CRITICAL DESIGN REVIEW UH-1N HELICOPTER RESCUE HOIST

TECHNICAL REPORT ASD-TR-73-25

JULY 1973

This technical report presents the findings and recommendations resulting from the design review. The review covers work conducted from August 1972 through January 1973.

UPPER WINCH MOUNT

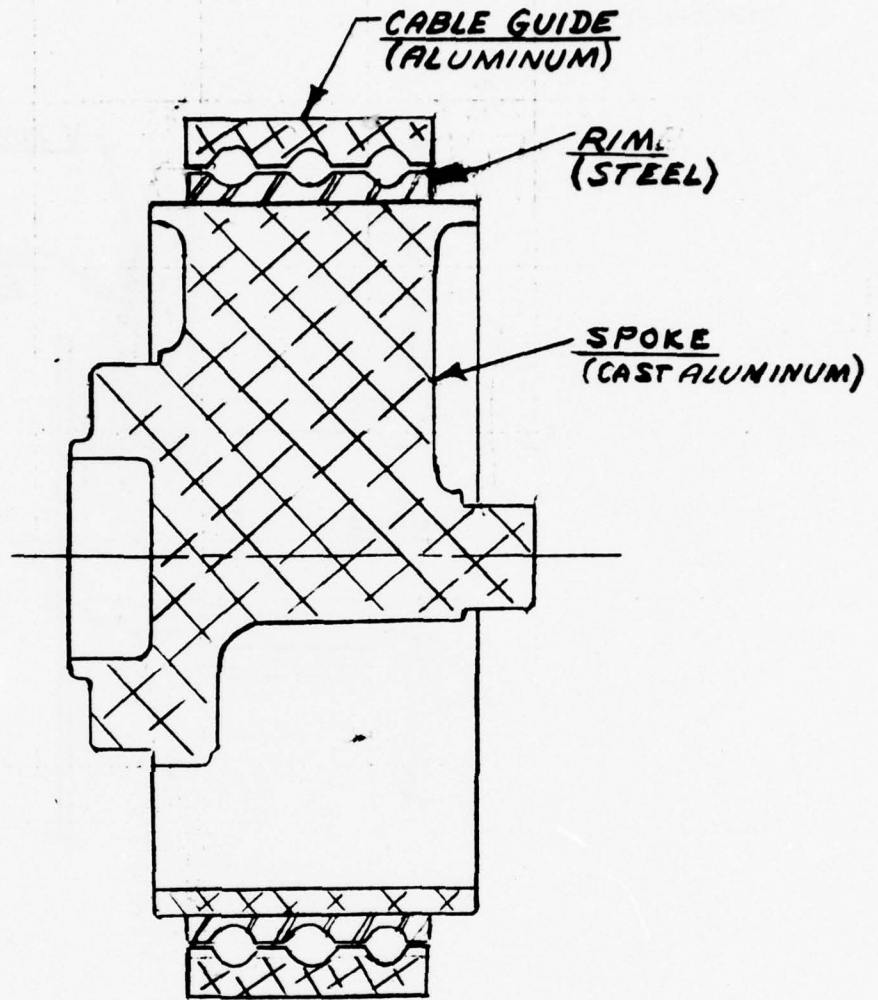
(4) Winch-to-Mast Connection - The brackets which facilitate mounting the winch on the vertical mast have been analyzed and found to be structurally adequate. It was determined, however, that a potential cable snag area is formed by a hex head bolt in the top mounting bracket (Fig 2). This condition can be corrected by substitution of an oval head machine screw.

(9) Upper Winch Mount - Replace the hex head bolt in the upper winch mount with an oval head machine screw to eliminate a pocket for potential cable fouling (Fig 2).

SECONDARY CAPSTAN (SECTION)

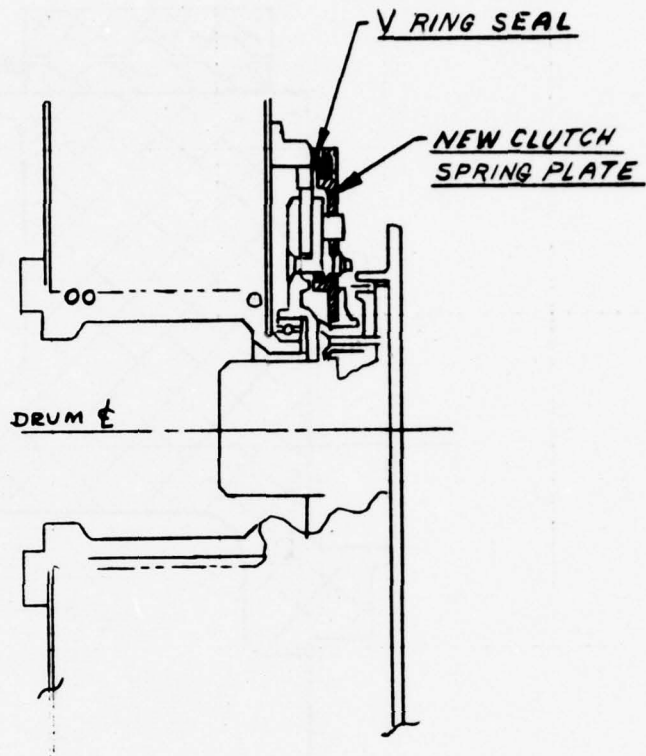
(c) Corrective Design Change - The in-house review team and Breeze Corp analyzed the failures described in (a) and (b) above. The out-of-tolerance condition was considered a possible cause for the lateral rim slippage but was discounted as a reason for spoke failure. Excessive winch bearing mount deflection was also considered as a potential cause of both the spoke failure and the rim slippage. This consideration was based on the fact that original winch qualification (endurance cycling at high load) was conducted at Breeze Corp with the winch mounted on a relatively massive test fixture. The CDR testing was conducted with the winch mounted on the relatively flexible mast. It was agreed that verification of such a theory would require additional extensive testing. The correction that appeared most promising was incorporation of a steel capstan of heavier section than the present cast aluminum/steel design.

(2) Secondary Capstan - Incorporate a steel secondary capstan in the winch to replace the existing aluminum and steel unit (Breeze P/N BL-5164). Configure the grooved surface so that the need for a side spacer (P/N BL-8079) is eliminated.

STORAGE DRUM CLUTCH SEAL (SECTION)

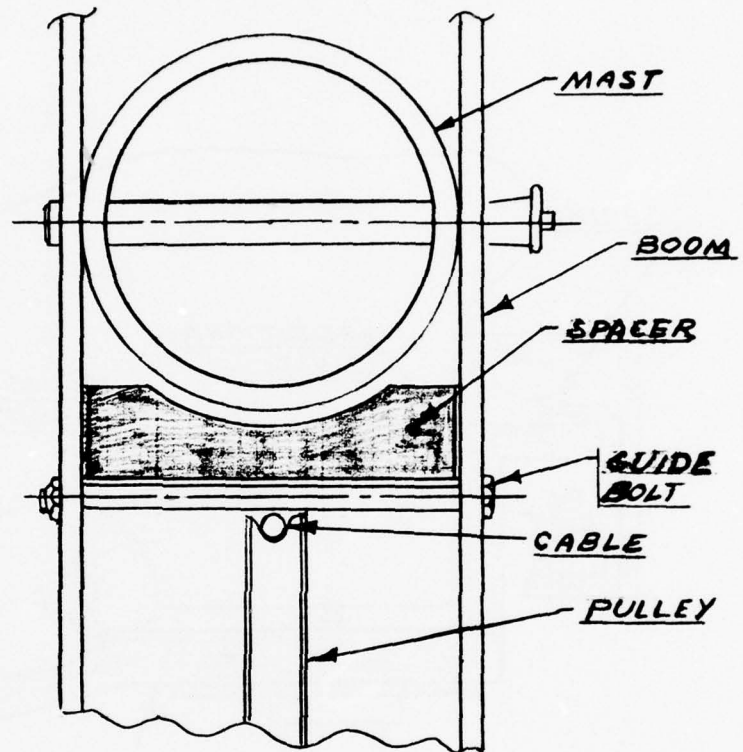
(a) Cable Spooling - When foreign material, such as water or grease, infiltrate the clutch area, the tensioning function of the clutch deteriorates to the point where the cable spools on the storage drum. This spooled cable can, and does, loop over the drum flange and fouls/binds when cable is subsequently payed out. This binding action creates excessive tension which finally severs the cable. Entry of foreign material can be stopped by installing a permanent clutch area seal (Fig 4).

SPACER TO PREVENT MISREEVING

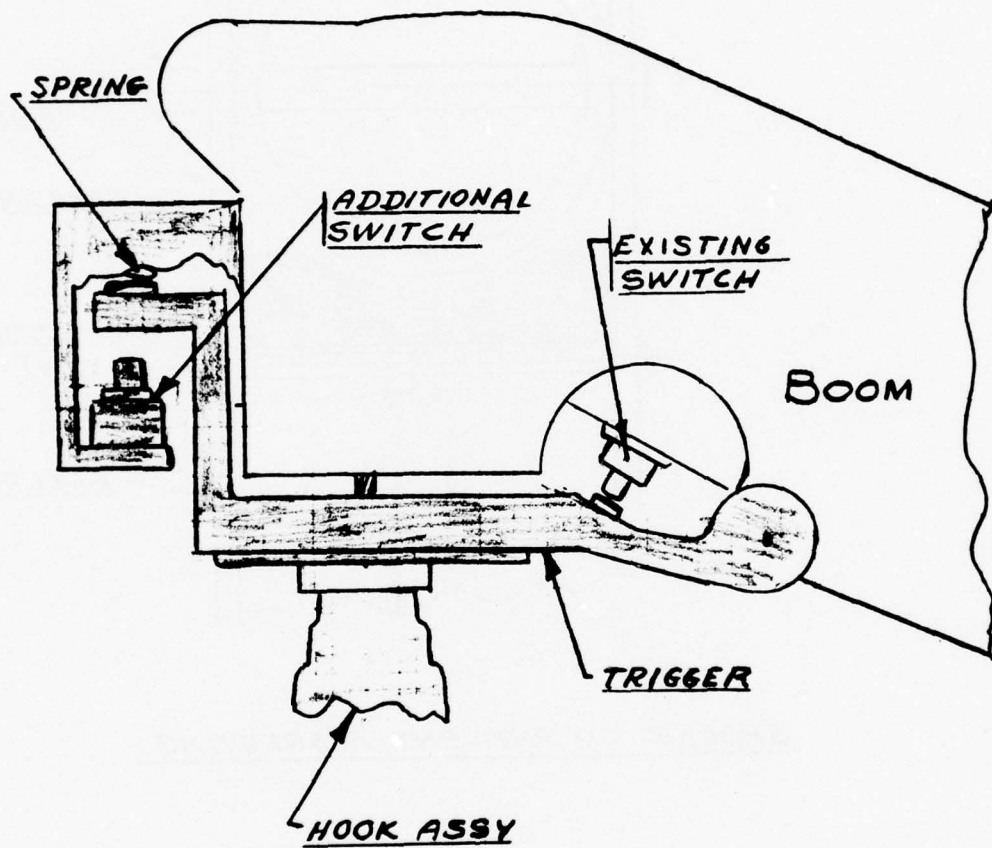
(2) Pulley - Although smaller than recommended by cable manufacturers for optimum cable life, the inboard boom pulley (Fig 1, item 28) is considered adequate in structure and cable interface. The adequacy is, however, dependent on cable replacement within prescribed intervals. With regard to installing a new cable on the hoist, there is a configuration in this area that has led to a misreeved and subsequently failed cable. The cable guide bolt (Fig 1, item 34) is located so that cable can be reeved over the bolt rather than properly between the bolt and pulley. The potential for misreeving could be greatly reduced by incorporating a spacer to block out the area between the bolt and the mast. The area in question and spacer configuration are schematically depicted in Fig 5.

UP LIMIT SWITCH

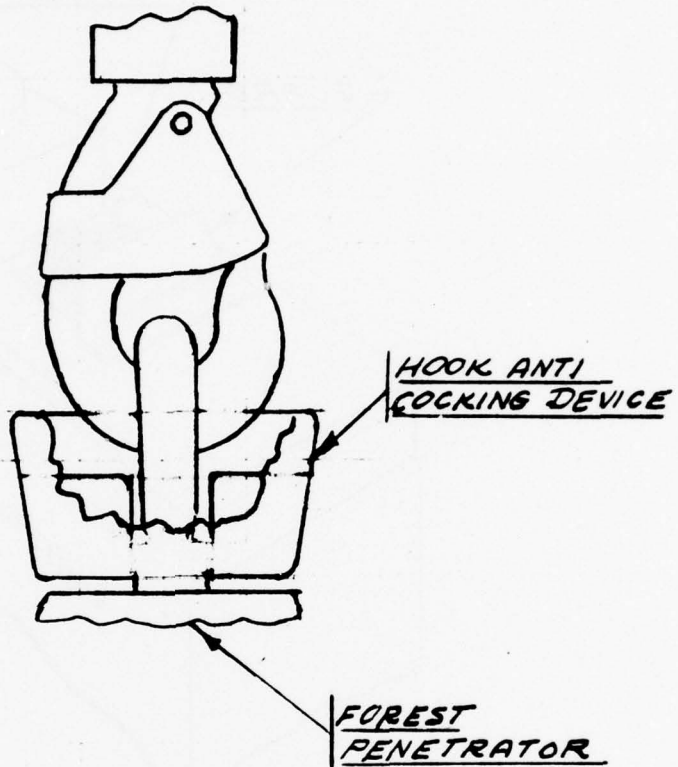
(c) Corrective Design Change - Considering the above, it is apparent that a rather extensive up limit switch assembly redesign is required to insure near fail safe performance. A design of this type would incorporate full redundant electrical circuitry, would not be adjustable in the field, and would have rugged construction to resist deformation. One such design is schematically depicted in Fig 6.

(1) Hoist Up-Limit Switch - Redesign the hoist up limit switch to provide partial mechanical, and full electrical, redundancy (including the control box power relay), to eliminate field adjustment, and to provide more structural integrity. See Fig 6 for a schematic depiction of design features and Section II for rationale.

ANTI COCKING DEVICE

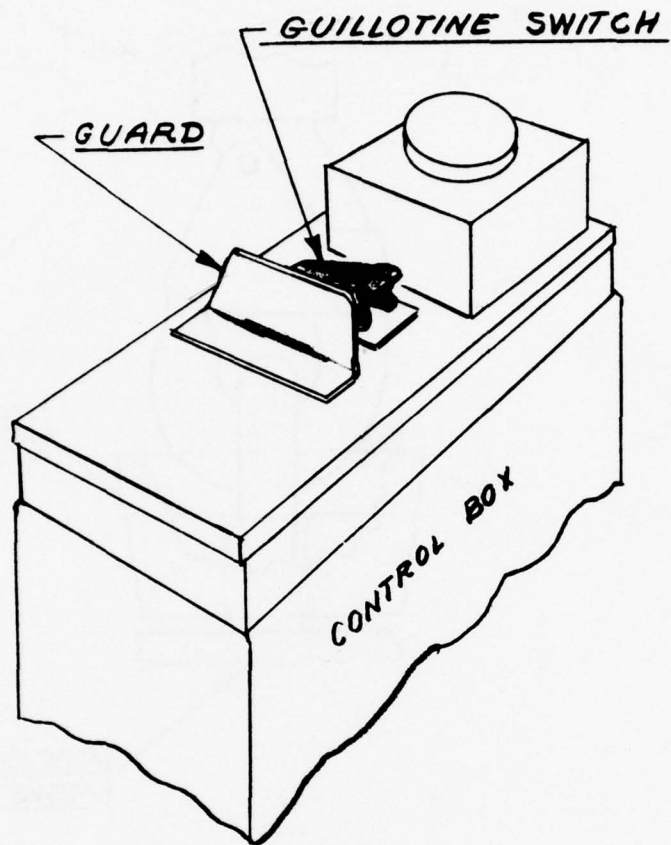
(7) Hook Anti-Cocking Device - Provide hook anti-cocking devices for use with the forest penetrator (Fig 7). This device will reduce an adverse cable loading condition caused by a sharp bend at the ball end fitting.
